SERVICE INFORMATION LETTER NO. 0166 Page 1 of 3

1. SUBJECT: Main Rotor Gearbox Bolt Retorque

2. MODEL: F-28A, F-28C, F-28F, 280, 280C, 280F, and 280FX

Figure 1. Main Rotor Gearbox Attachment Bolts

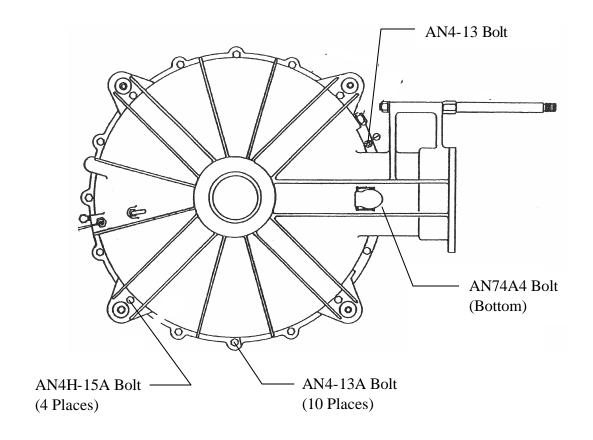
- A. Defuel helicopter.
- B. Remove tanks.
- C. Locate the main rotor gearbox bottom cover attachment bolts (reference Figure 1).
- D. Remove safety wire.
- E. Remove lead seal as required and note on the component record card that the SIL was complied with and the lead seal was removed
- F. Retorque each referenced nut and bolt to 100 in-lb.
- G. Safety wire bolts.
- H. If the torque has not changed, no further action is required.
- I. If the torque has changed, retorque again at the next scheduled inspection.
- 5.2. PARTS: MS20995-C32 Safety Wire, As required.
- 6. SPECIAL TOOLS: None
- 7. MAN-HOURS: 2-4 Man-hours
- 8. WARRANTY: Per Enstrom New Helicopter Warranty policy.
- 9. WEIGHT CHANGE: None
- 10. LOG BOOK ENTRY: As required for maintenance actions.
- 11. REPETITIVE ACTION: See 5.1.I.
